Re: **Comments on General Electric's April 2000 "Baseline Monitoring Program Proposal for Plant Site 1 Groundwater Management Area", General Electric (GE) Housatonic River Project Site, Pittsfield, Massachusetts.**

The United States Environmental Protection Agency (EPA) has reviewed the April 2000 submittal prepared by the General Electric Company (GE) titled "Baseline Monitoring Program Proposal for Plant Site 1 Groundwater Management Area" (GMA-1).

Figure 2
Groundwater Management Area -1
GW-2 Area - High Water Levels

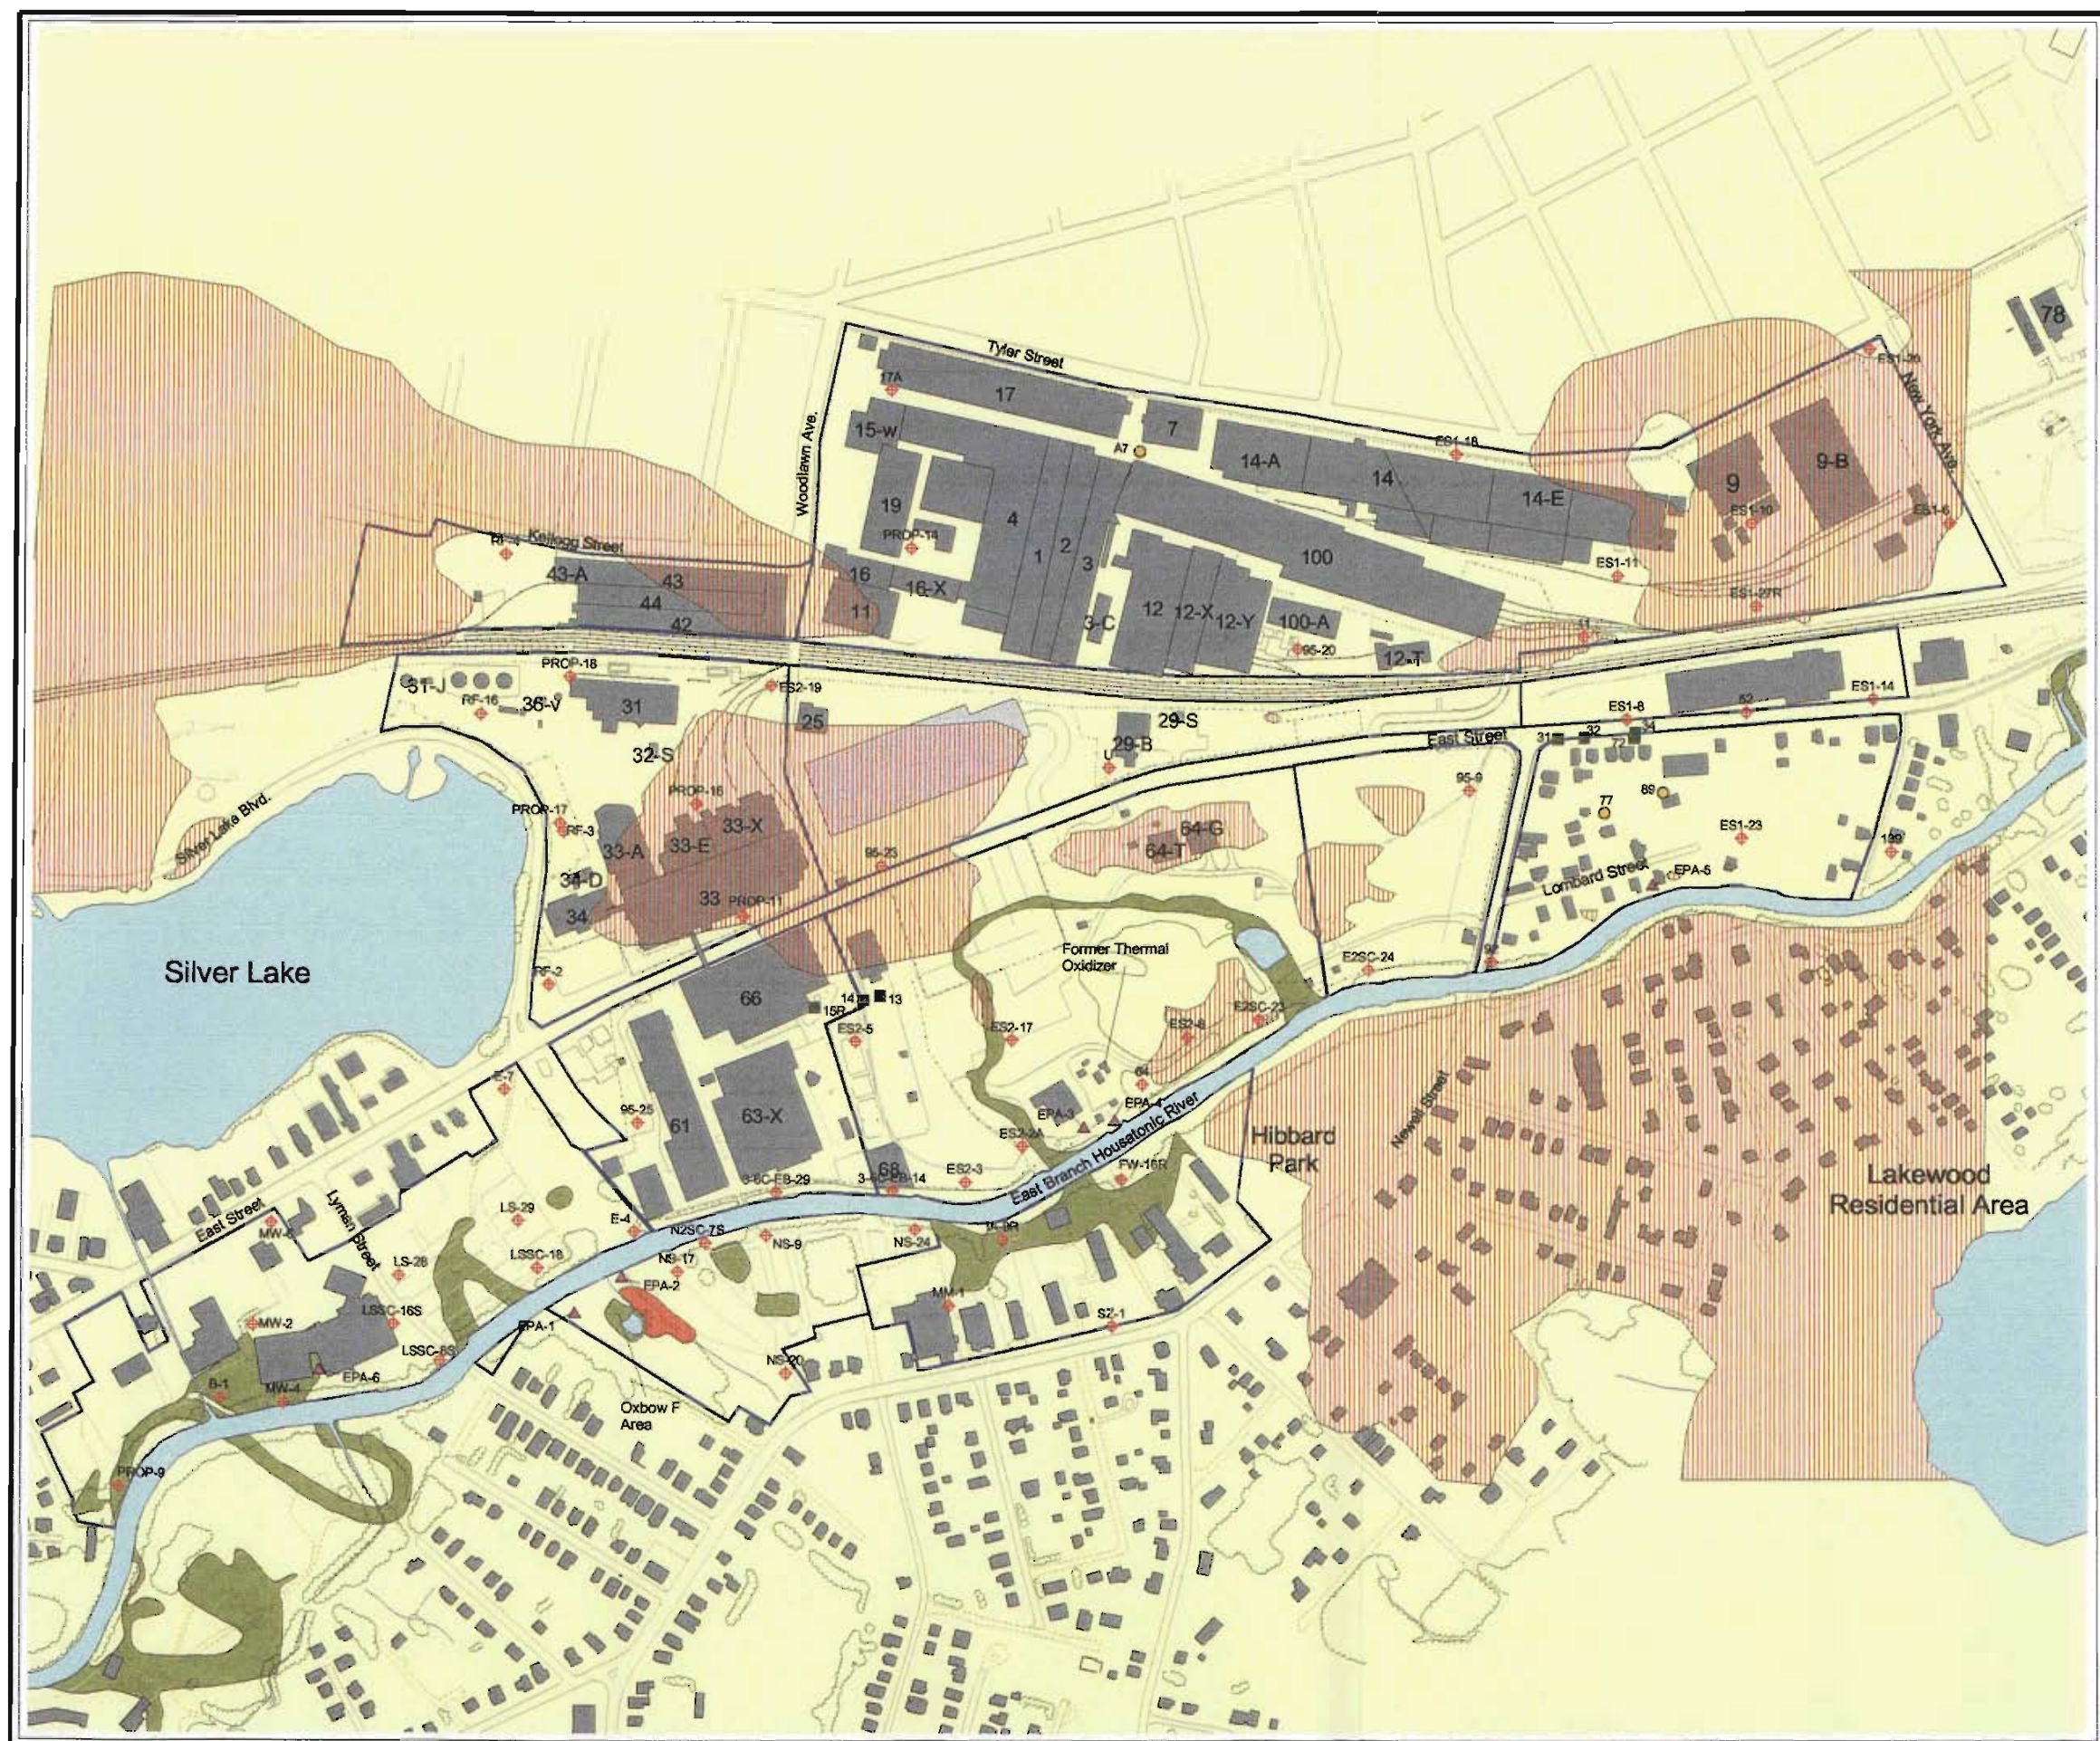
4. Section 4.2.2 and Figures 2 and 3. According to the MCP, the average annual depth to groundwater needs to be used for determining areas where GW-2 standards are applicable. GE has presented the average high and low groundwater elevations in the GMA-1 proposal. GE needs to use the overall average or explain how it is using the high and low groundwater levels to determine areas where GW-2 standards are applicable.
